**Appendix 9**

# The Old Power Station, Design Addendum

## 12 November 2020

This document has been produced in response to the comments received on 22 October 2020 from Darren Cook, Transport and Development Control Manager, and Mark Worringham, Area Planning Team Leader.

**Figure 1.2**  
Line of Sight from the Station to Christchurch Bridge

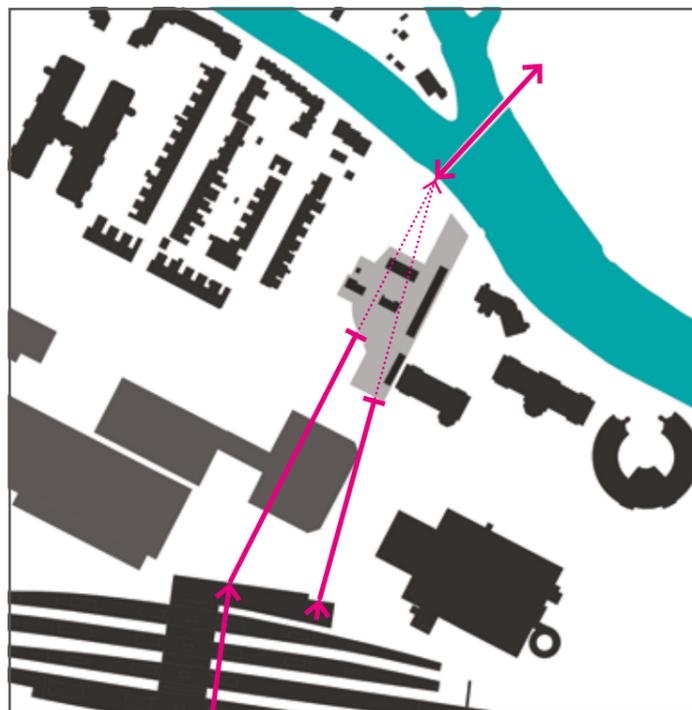
Extrapolating a line of sight from each of the access points, through to the landing of the Bridge, demonstrates that neither route would be achievable owing to the retention of the SSE equipment.

**Figure 1.9**  
Comparing Against  
RSAF Plan 4.1

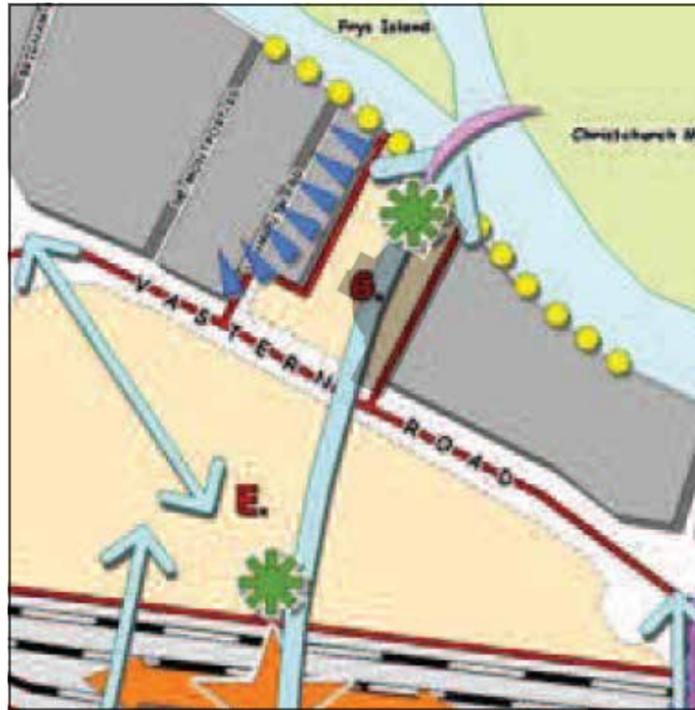
Planning Policy RC1, and the accompanying Illustrative Strategy Plan contained in RSAF Figure 4.1, illustrate that a route should be formed between the Station and Bridge.

As seen on this illustrative plan, the route to the bridge was not necessarily envisaged to be straight - this plan shows a curved route connecting the two points.

This follows the same strategy as our scheme (see figure 1.6 above).

(Note, the grey overlay of the SSE site demonstrates the illustrative route is not possible in this exact location).

**Figure 1.10**  
Comparing Against  
RSAF Plan 11.11

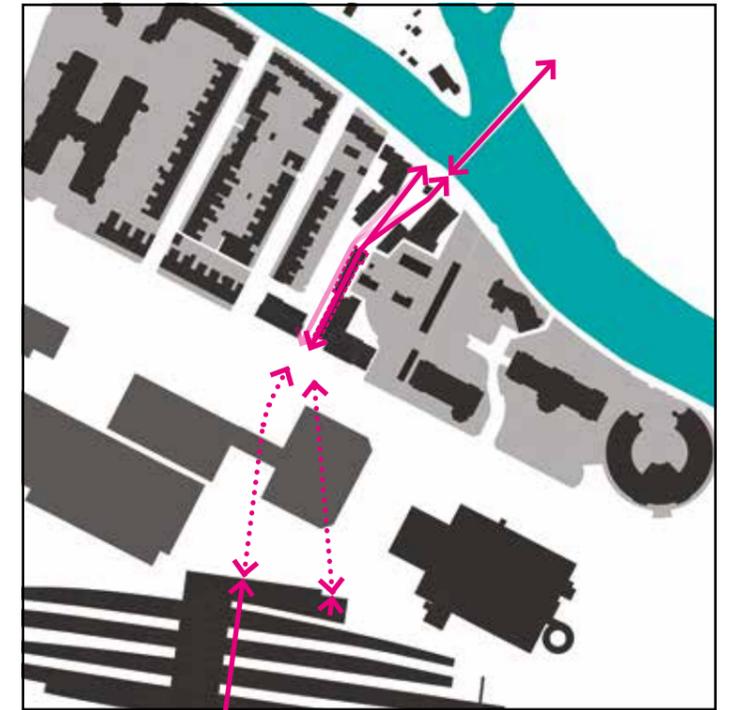
RSAF Figure 11.11 shows the proposed cycleway infrastructure (red dashed lines) and how they would connect to the current infrastructure.

This plan demonstrates that a linear route is illustrated, but with two deflections to the route as it approaches the Bridge (highlighted by the pink circles), so not a "straight" route.

It is also worth noting on this plan, that the route as suggested would not be possible with the retained SSE equipment, and simply moving the route wider to the west would render the resultant site unviable and as such no such connection could come forward.

**Figure 1.11**  
Reduction in Development

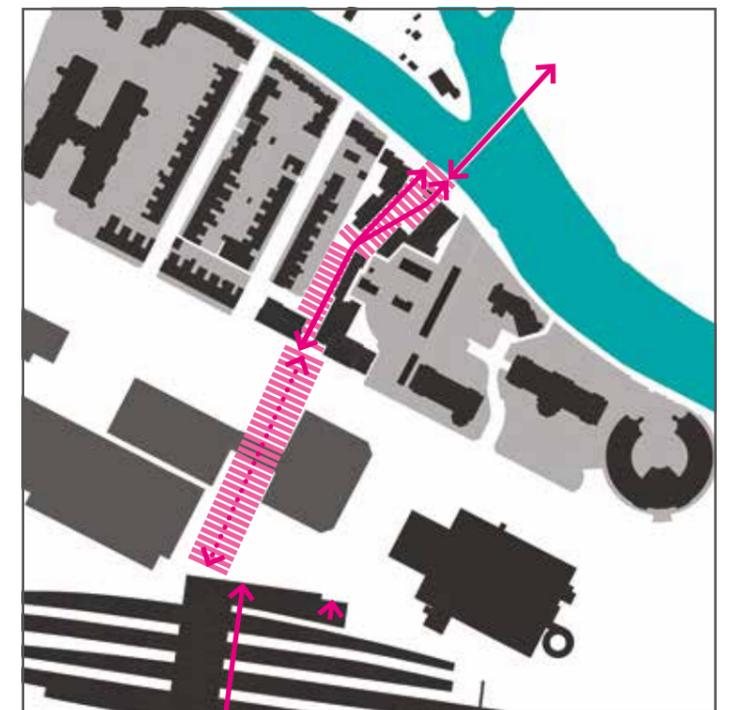
Of the feedback given to date, it was suggested within the response from Mark Worringham that the "main problem" with the directness is "the presence of the 'Goods Office' plot" and that "the extent of the Goods Warehouse also accentuates this issue".

As demonstrated within this figure, the loss of the Goods Office, and reduction of the Goods Warehouse buildings still result in a curve to the route and very little change to its connection to Vastern Road, perhaps only moving the route by ca. 3m.

This would also result in a loss of 20-21 dwellings.

**Figure 1.13**  
Submitted Scheme

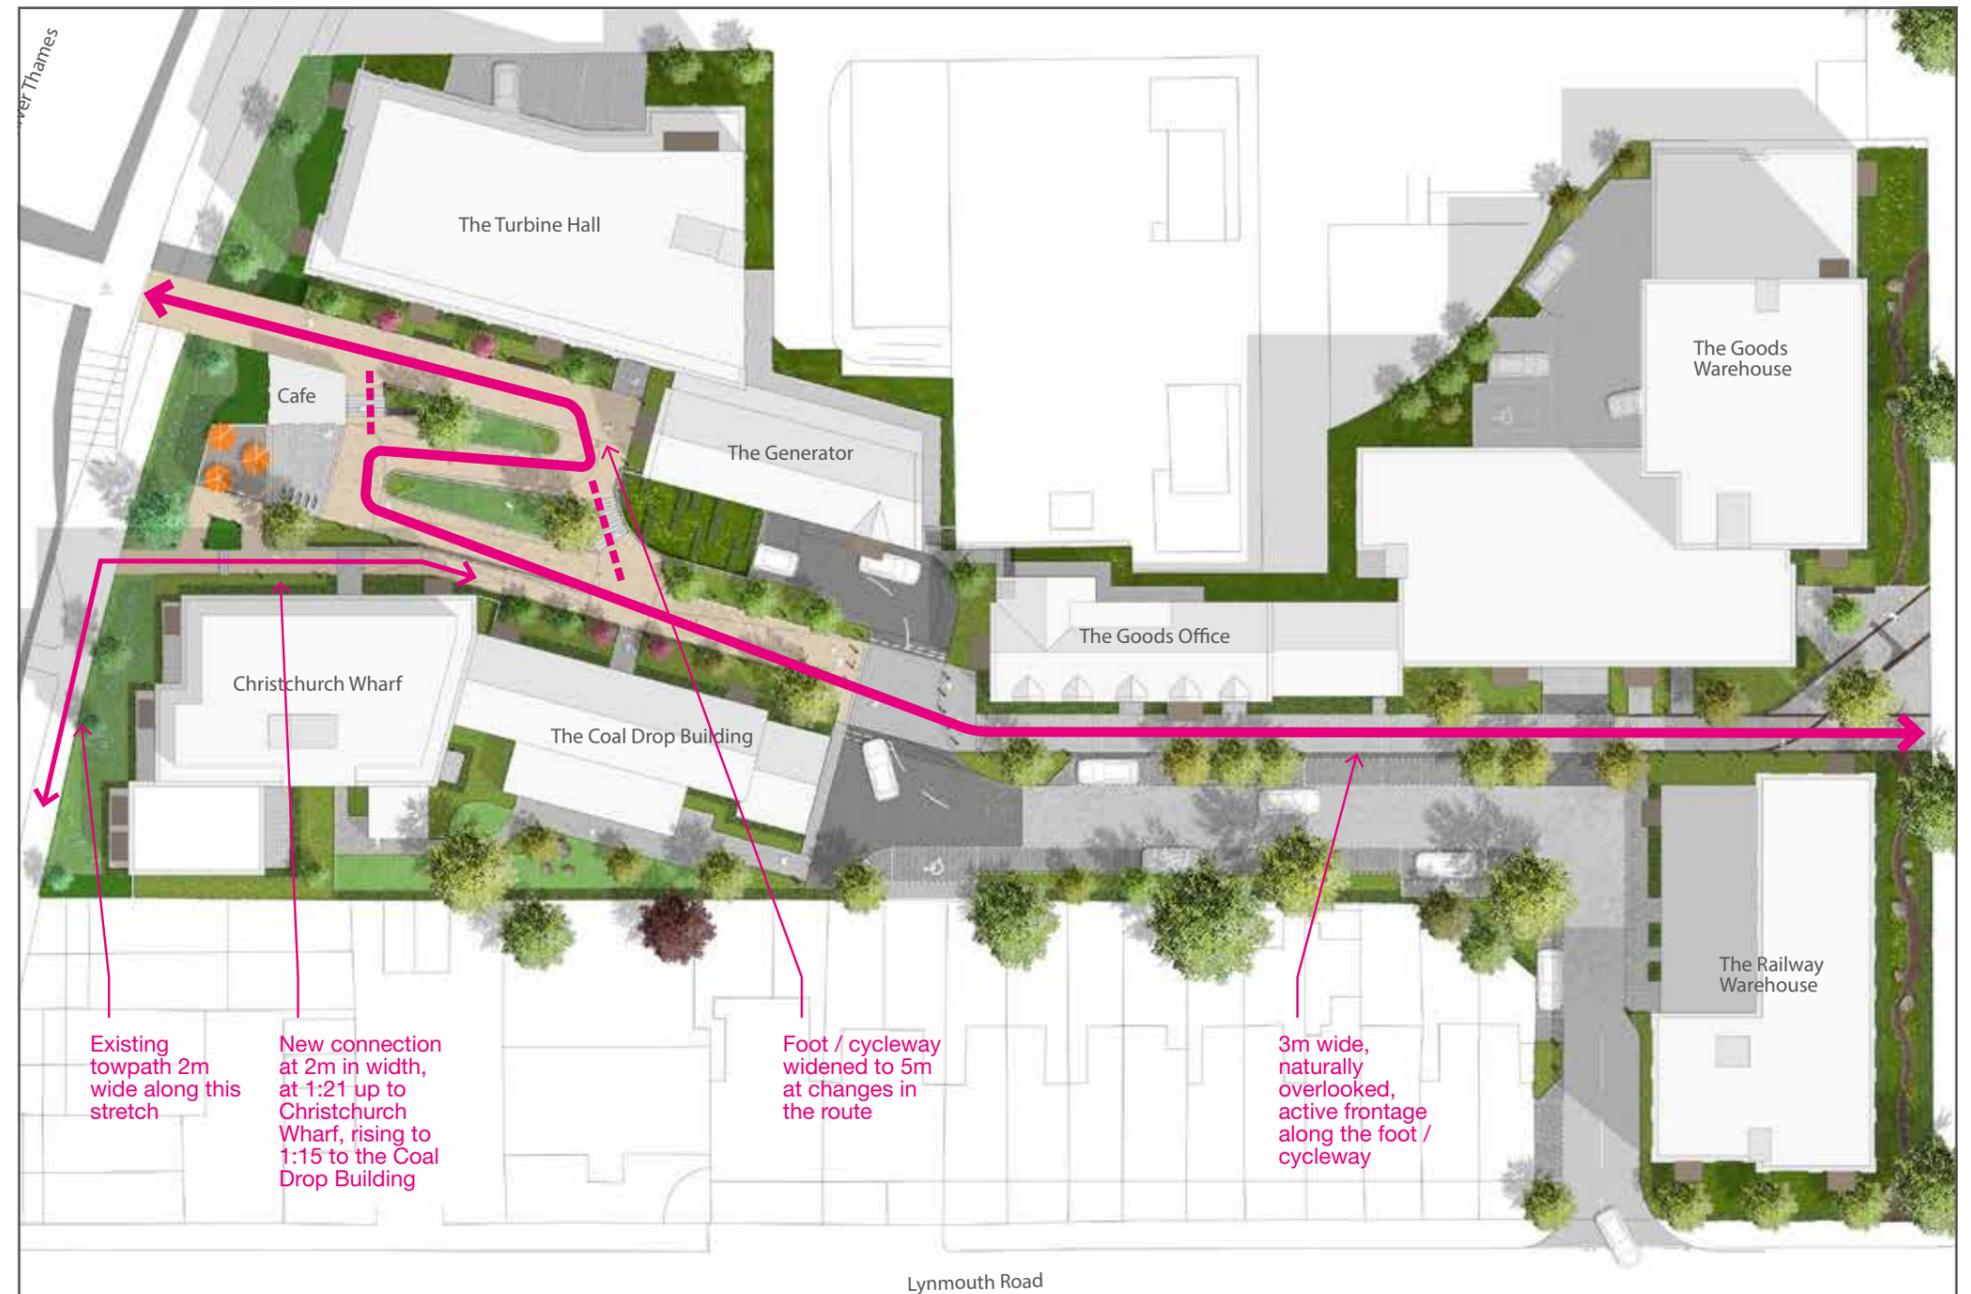
In the correspondence received on 22 October 2020, the widths of the proposed foot / cycleway through the site have been questioned and suggested that they are not wide enough.

The second point regarding widths is in relation to the approach and gradient connecting to the Thames Towpath, stating that our route is too narrow (2m wide minimum) and gradient too steep (1:15 maximum).

On the main route to and from the Bridge, as noted in figure 1.12 above, the foot / cycleway as proposed through the scheme is 3m in width as a minimum, increasing to 4m to the connection on to Christchurch Bridge and on changes in direction.

However, it should be noted that the widths of the streets within which the route sits is generally 15m wide, increasing to over 25m towards the River Thames. This route is no greater than 1:21, and as such the width and gradient is in accordance with the DfT guidance, as well as the requirements contained within CD195 Rev.1 - Cycle Route Design. It should also be noted that pre-application advice received 7 October 2019, and 12 December 2019 contained confirmation that the foot / cycleway route to the Bridge would be acceptable at 3m in width.

conversion of the towpath to a foot / cycleway, this does not appear to have materialised as yet, although we are advised it is under review / consultation at present. Within the objections, and Officers responses, it was accepted that the provision of a foot / cycleway of a reduced width was better than none, and that in accepting the Towpath along this stretch is only 2m wide (i.e. the same as our link to it) that the DfT documentation was guidance only (see paras 4.7-4.8 of the committee report).

It should be noted that gradients and subsequent landings on the Towpath route have been designed in accordance with Building Regulations.

As such, we maintain that this access is a benefit to the site, and is proposed to be in keeping with the Councils own advice on the towpath itself.

**Figure 1.14**  
**Alternate Route Option 1 -**  
**Descend from Bridge**

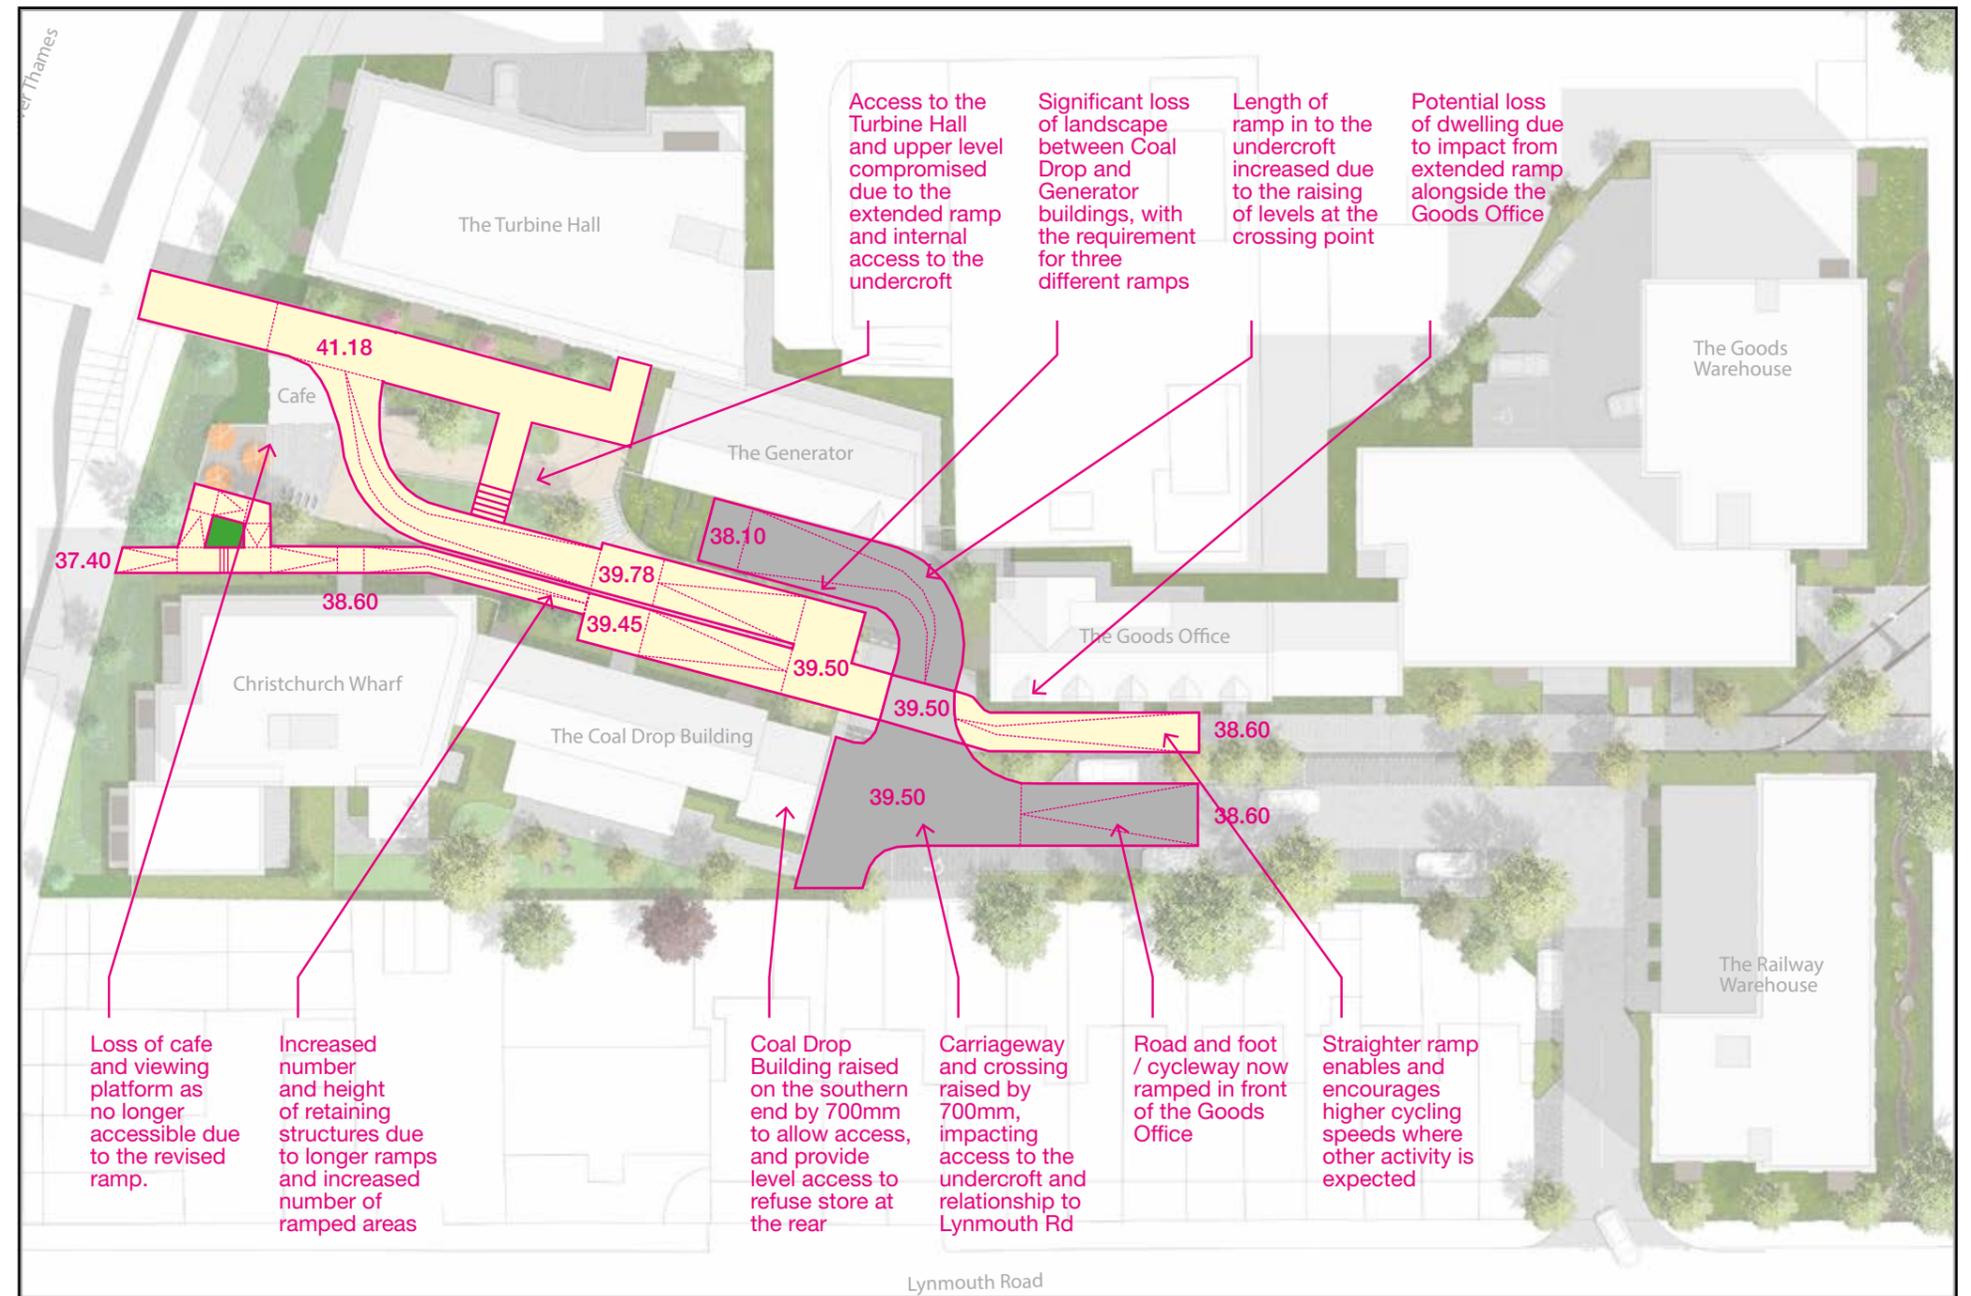
Finally, to address the comments in relation to exploring a straighter route, as demonstrated on the previous figures this is not achievable due to the retention of the SSE equipment.

However, in order to assess the impact on the development an illustrative scheme is set out below which removes the "switchbacks". For the purpose of this diagram, it is assumed that the response in figure 1.13 is accepted in relation to the width of the ramp to the towpath.

This proposal would see a single ramp from the bridge level, down towards the vehicular crossing point in to the northern undercroft parking area. The ramp would be 3m wide, increasing to 3.7m in width for the second part in order to allow fire appliance access to the Turbine Hall.

As this ramp would then meet the ramp from the Towpath further into the site, the Towpath route would also need to increase to 3.7m in width in part to allow fire appliance access to Christchurch Wharf.

Between the Generator and Coal Drop Buildings, this would see three hard surfaced ramps all at different angles alongside each other, increasing the extent of hardstanding to 13.5m in width (leaving only 1.5m for soft landscaping). This would leave the occupants of Christchurch Wharf and the Coal Drop Building facing out on to hardstanding and retaining walls of up to 2.8m in height (only ca. 2.5m from their windows), with

The extent of raised area would extend a further 31m south from its current position. This would require the road, crossing and turning area to be raised by 600-800mm, resulting in a loadbearing carriageway against the gardens of the properties along Lynmouth Road, and both the Coal Drop Building and Goods Office would need to be raised to the same amount in order to access the properties and refuse stores. We would also see a loss to the parking undercroft to the Turbine Hall due to the increase ramp.
